STATE OF NORTH CAROLINA
DEPARTMENT OF TRANSPORTATION

May 1, 2020

Subject: Revised Modification Request for the Section 404 Individual Permit and Section 401 Water Quality Certification for the proposed Havelock Bypass in Craven County. TIP No. R-1015. Debit \$ 570 from WBS 34360.1.2

PERMIT DRAWING
SHEET 148 OF 167

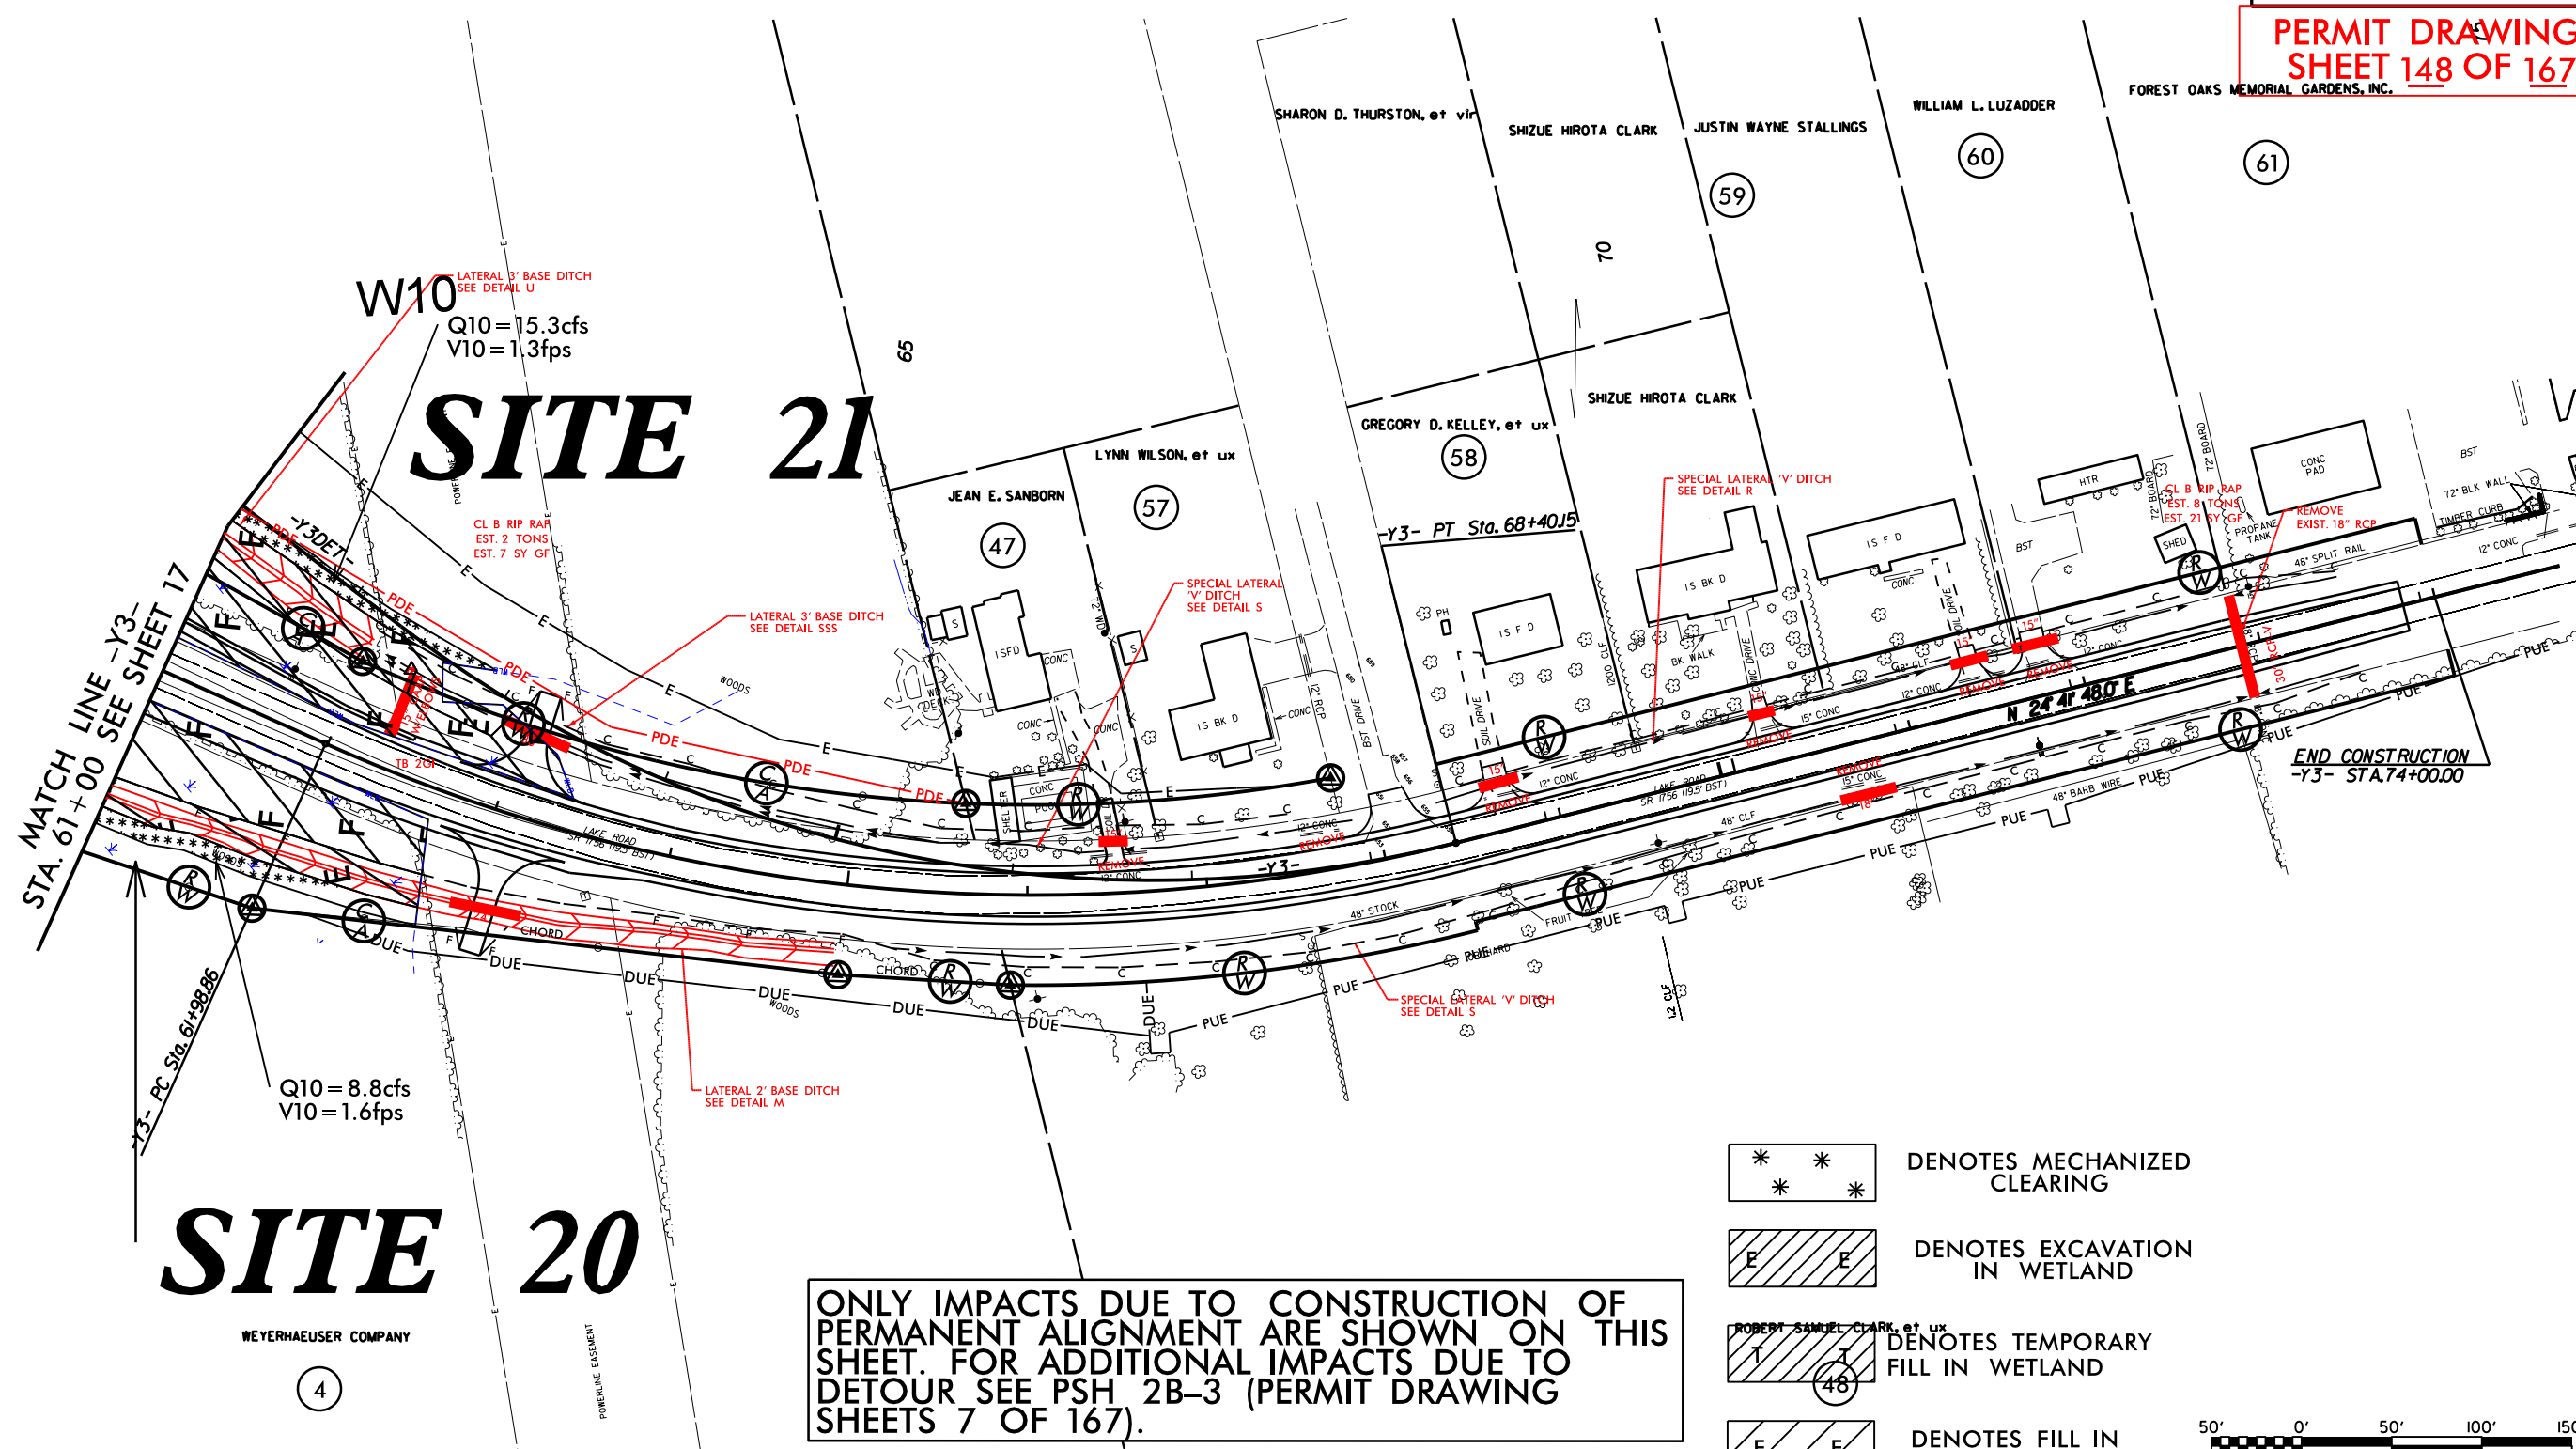
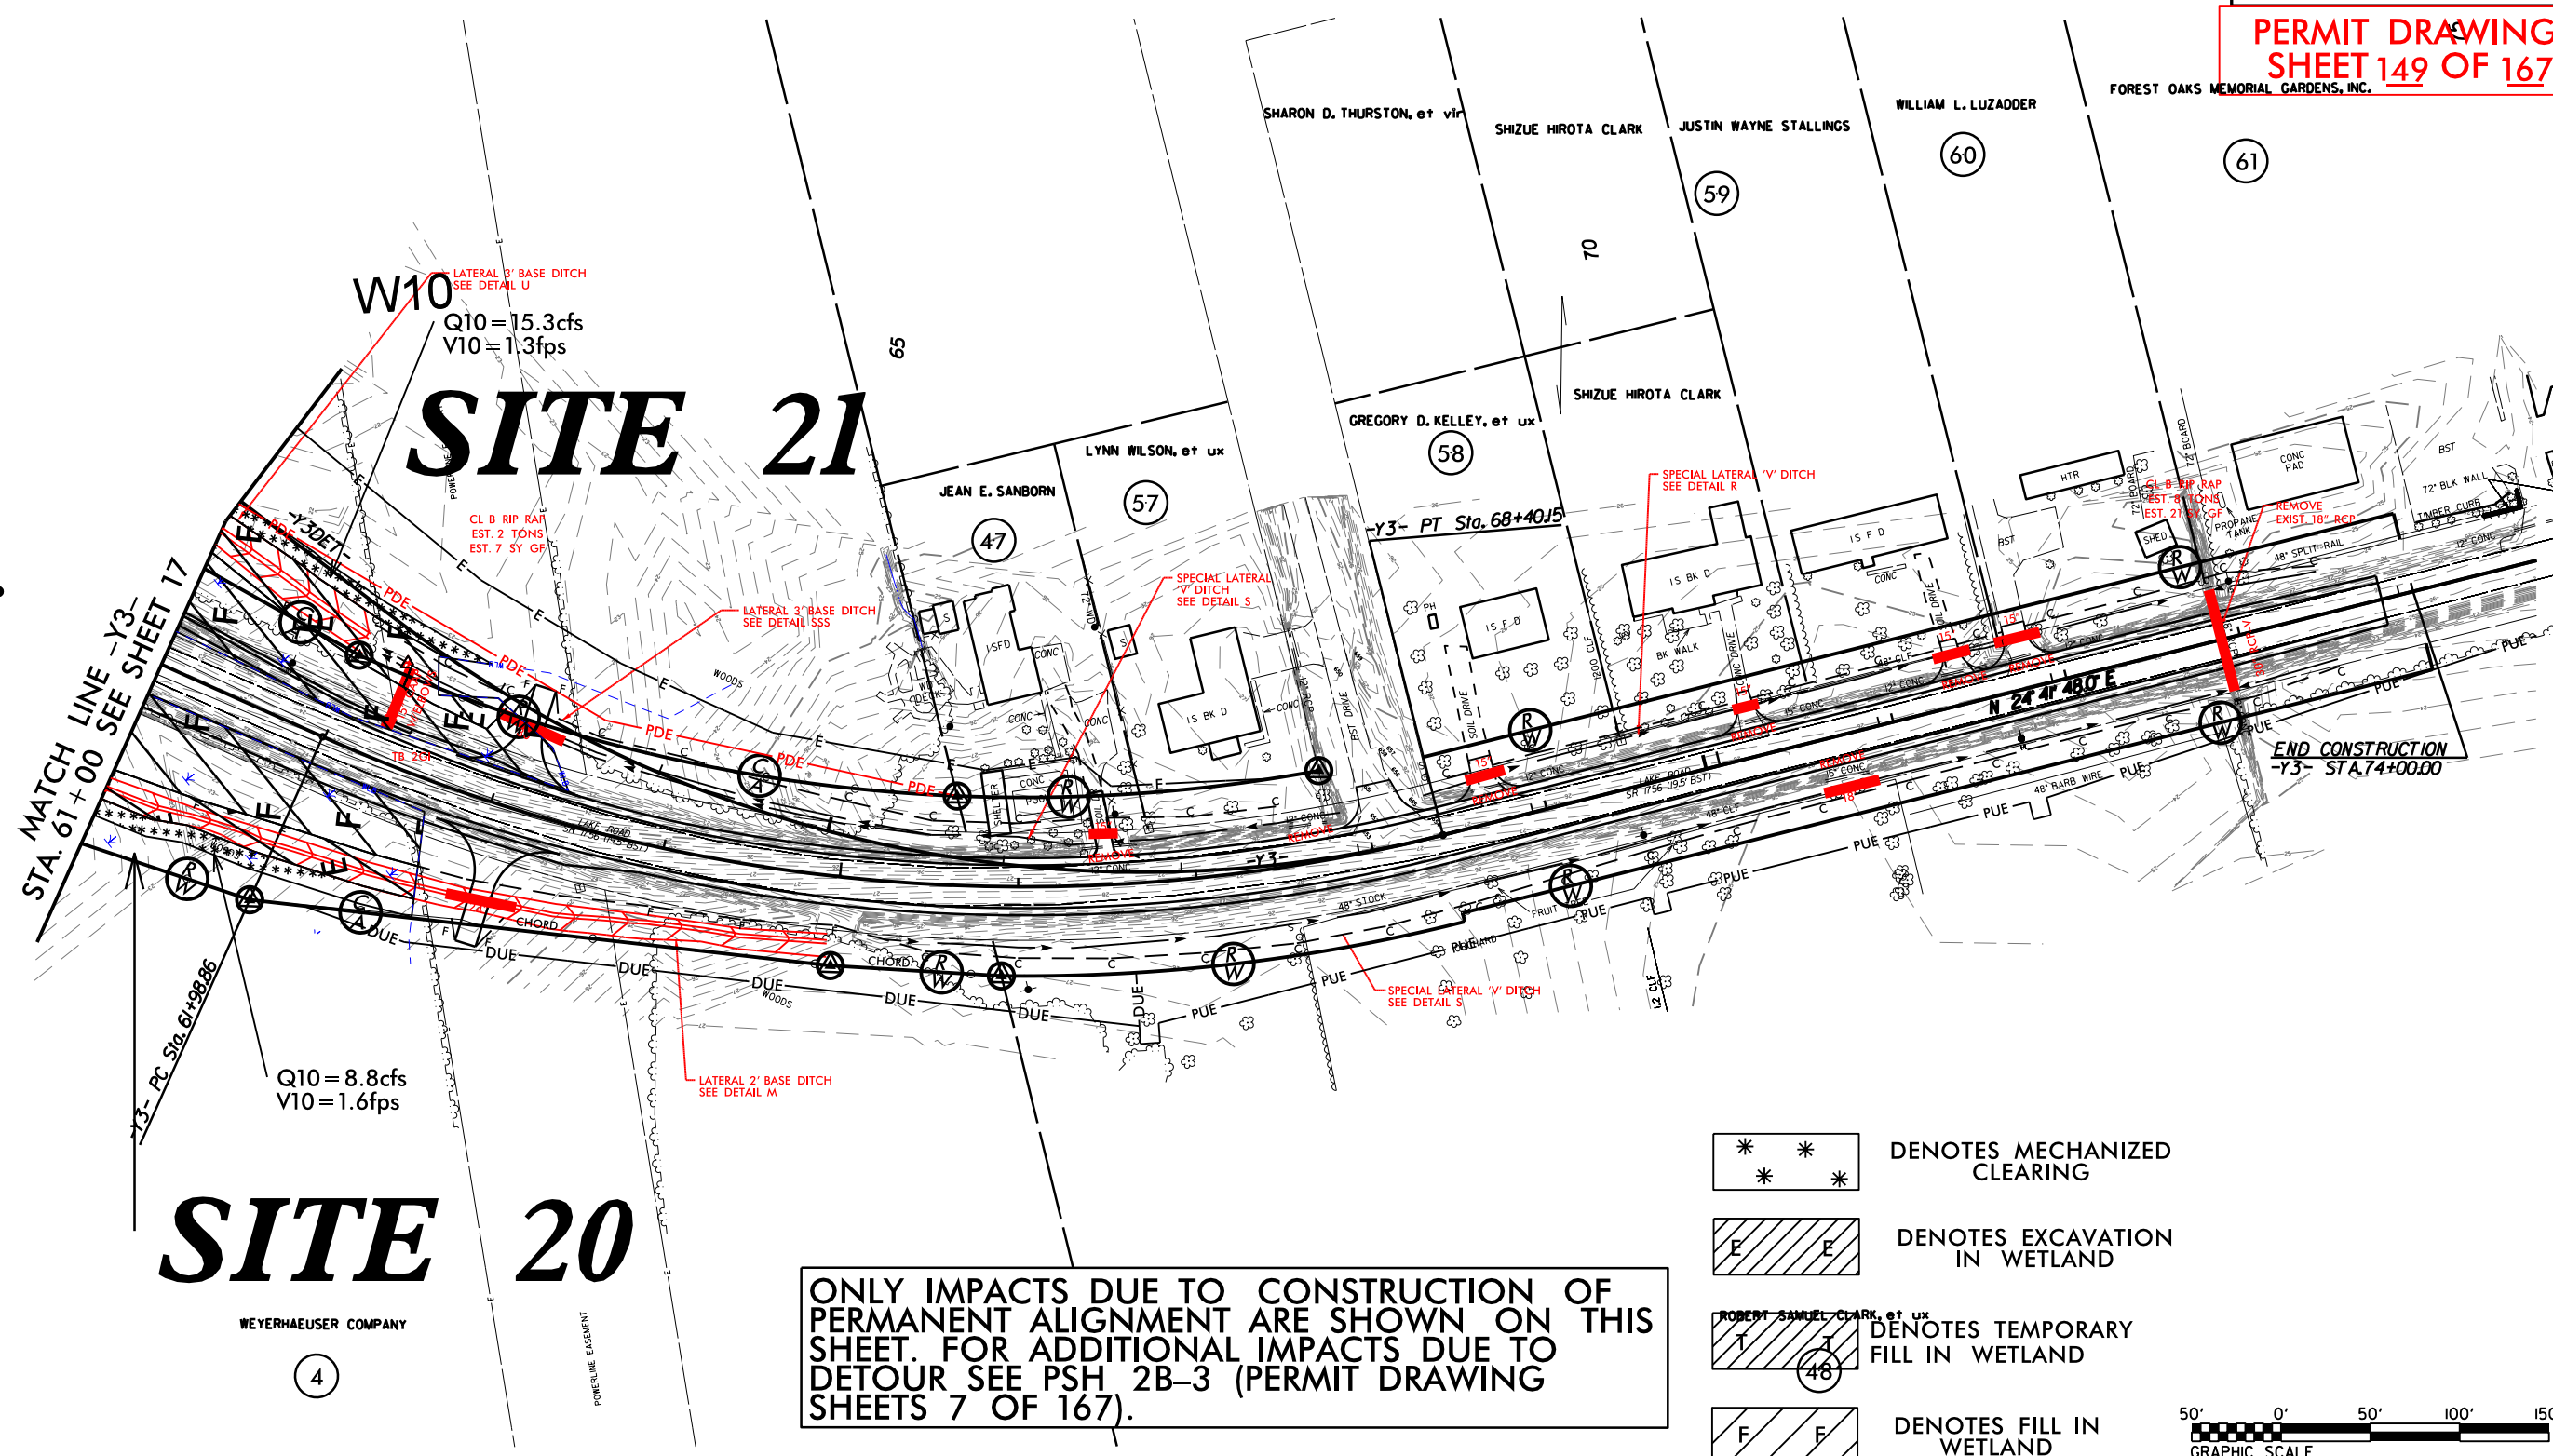
- Site 21 (permit sheets 148 & 149) pipe outlet shifted, fill increased, excavation decreased, no change to total impacts permitted for site (0.85 acre).
